File 1980-0006  
Date 6/5/01

Project Name: Falls - Part 2 of 2

FINAL DEVELOPMENT PLAN  
 FOR  
 THE FALLS, FILING TWO, LOT 8, BLOCK TWO

REVIEW SHEET SUMMARY

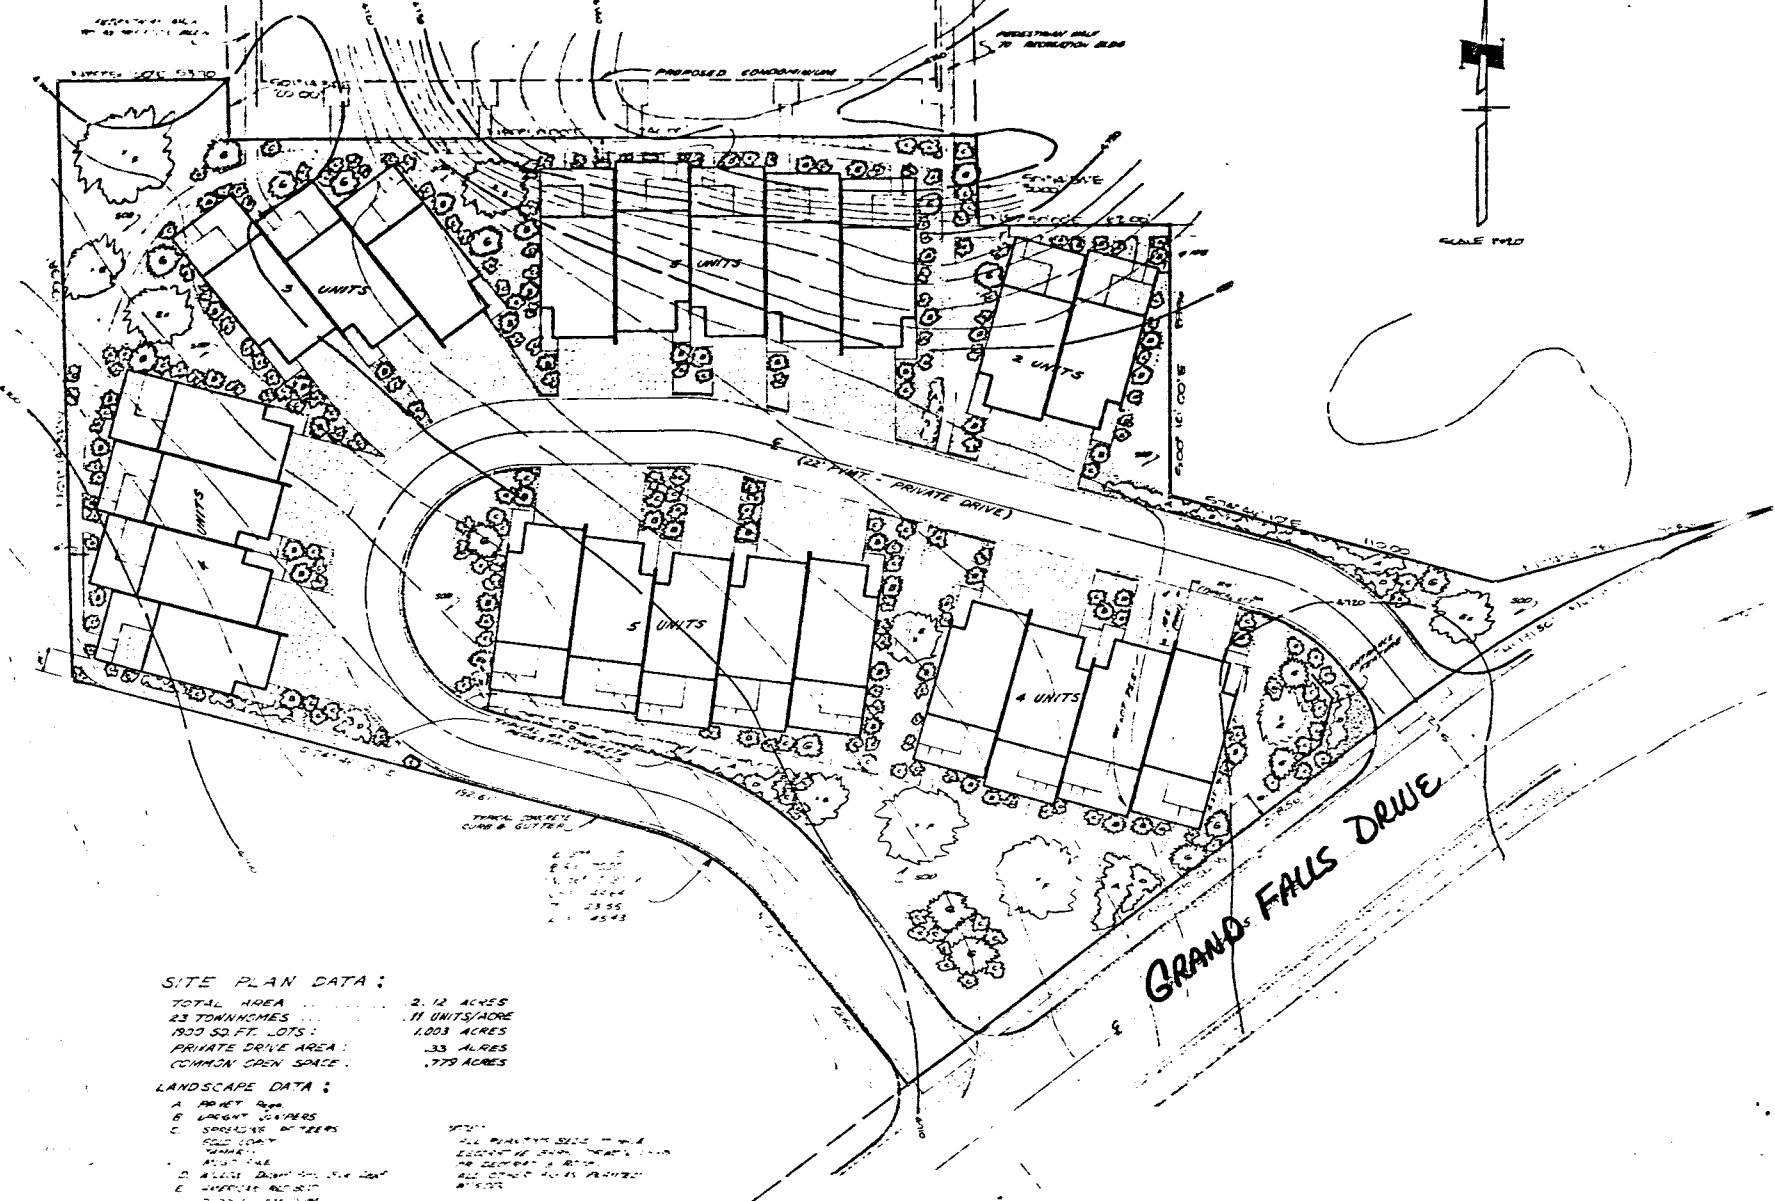
- 1) Who will be responsible for the private road & how will it be maintained?
- 2) Will off street parking be provided for each units?
- 3) Need to provide detail drainage plan.
- 4) Recommend that predestrain walk on the private drive be striped.

- 1) Parks & Rec.  
Is concerned about plant material listed to survive in this type of soil.
- 2) City Utilities  
Questions why its a private St. & not a publi St. & why the homeowners have to maintain the Street. Provide sewer service line to each unit & easements so manholes can be maintained.
- 3) Mt. Bell & Public Service  
needs required utility easements.
- 4) City Engineer  
Has not seen final plans for utilities & Street layout for this portion of filing #2.
- 5) The predestrain walk the private road be striped & a detail drainage plan be provided.

SIMONETTI/PRICE PASSED 4-0 (PICKENS ABSTAINING)  
A MOTION TO RECOMMEND APPROVAL TO THE CITY COUNCIL OF #6-80, THE FALLS SUBDIVISION, FILING #2, REPLAT OF LOT 8, BLOCK 2, FINAL PLAN, SUBJECT TO STAFF COMMENTS, RECOMMENDING THAT THE STREET BE A PUBLIC STREET AND NOT A PRIVATE DRIVE; THAT RESOLUTION OF THE STREET DESIGNATION OF PUBLIC VERSUS PRIVATE BE MADE BEFORE PRESENTATION TO CITY COUNCIL.

1. The petitioner desires to dedicate the proposed private road.
2. Attached is a revised final development plan indicating the addition of 23 parking spaces. Total parking provided is 5 parking spaces per dwelling unit.
3. Attached is a detailed drainage plan.
4. The pedestrian walk crossing the proposed road will be stripped.

1. Soil will be reworked to insure that plant materials listed can survive.
2. The petitioner desires to dedicate a public road in lieu of the private street. Sewer service will be provided to each unit and easements will be dedicated for proper sewer maintenance.
3. Required Mountain Bell/Public Service easements will be dedicated on the final plat.
4. See attached letter dated March 26.
5. The pedestrian walk crossing the proposed road will be stripped and a detailed drainage plan is provided.
